TRADE AND COMMERCE
CANADA

SD-EA.90

OTTAWA, December 15, 1952.

MODIFICATION OF TYPE APPROVALSANGAMO TYPE "SC" THERMAL GRAPHIC DEMAND WATTMETER

SANGAMO TYPE "NO" THERMAL GRAPHIC DEMAND METER

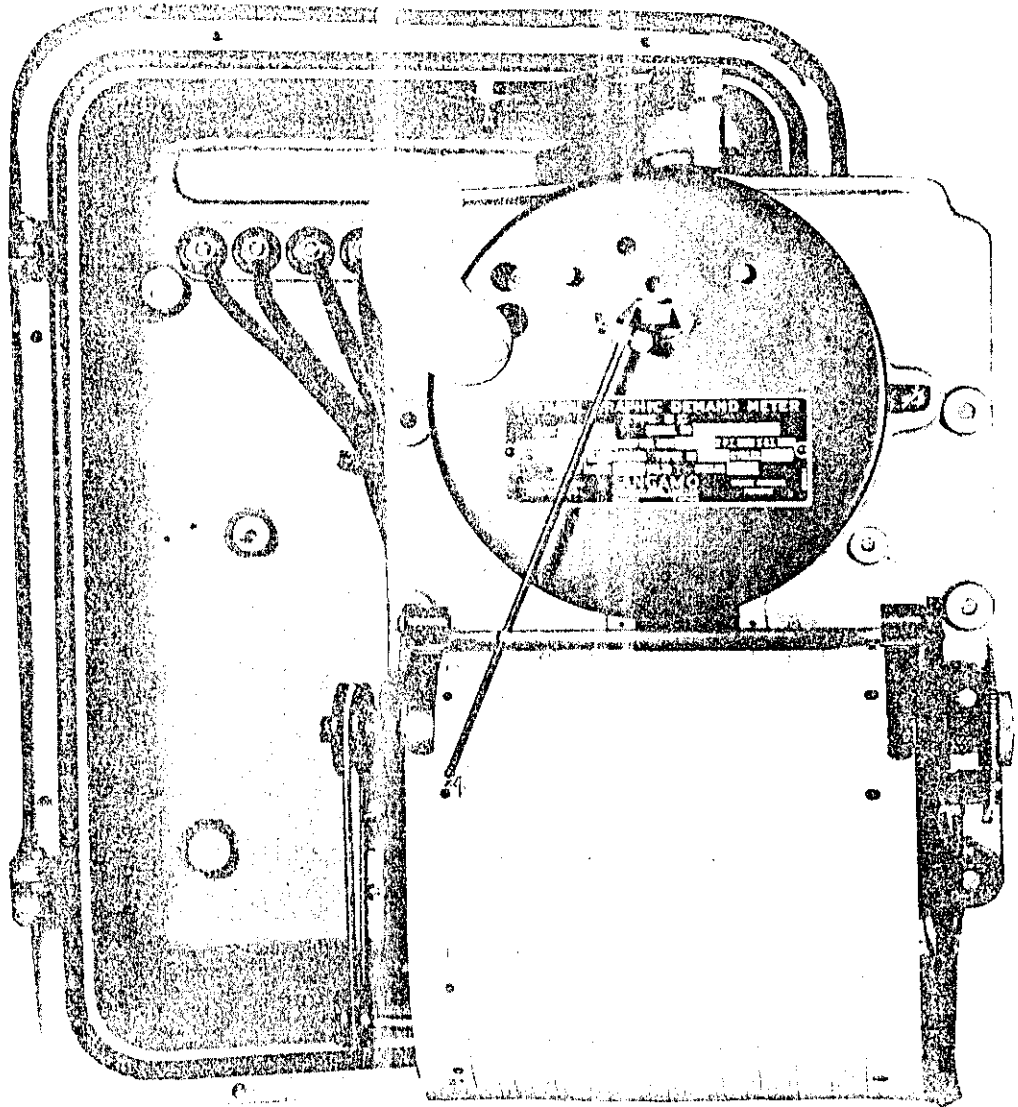
Description: The modification concerns only the enclosure and the mounting, and not the meter itself. In this arrangement the meter is mounted on a plate hinged in such a way that it can be drawn out for inspection. It is secured in place by a lever at the top of the case which must be pressed to the side to release. When swung out, the hinged section is locked out by the same lever. The mounting plate is free to pivot and is locked in one position, for inspection or service, by the knurled head pin.
